BELL SYSTEM PRACTICES
Teletypewriter and Manual
Telegraph Station and PBX
Installation and Maintenance

ADDENDUM P36.475
Issue B, 9-9-46
Long Lines Department
Dist. Class. 602.02

NO. 15 TELETYPEWRITERS
WORD COUNTER MECHANISMS
INSTALLATION AND ADJUSTMENT

Figure 1

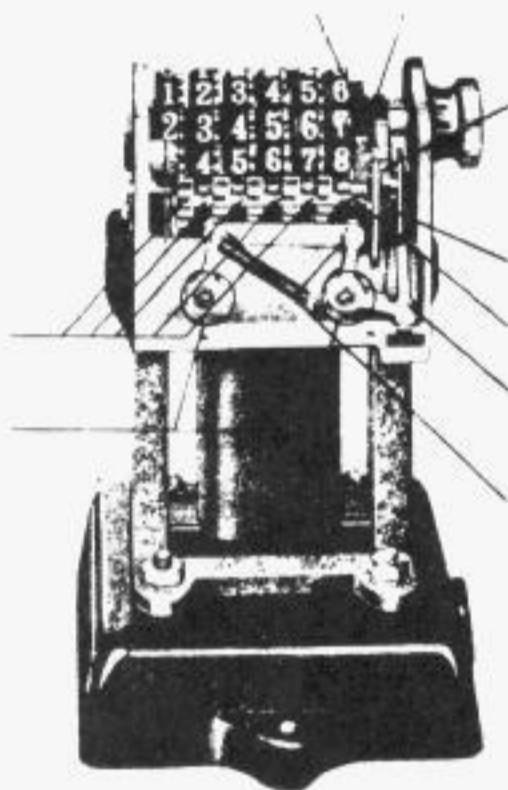
11.13 Apply sparingly with a tooth pick to the points indicated by arrows on Figure 1.

11.14 The circles identify the armature shafts which are open at the back. Each of these shafts should receive three or four drops of oil.

11.15 At longer intervals apply oil to the main (number wheel) shaft.
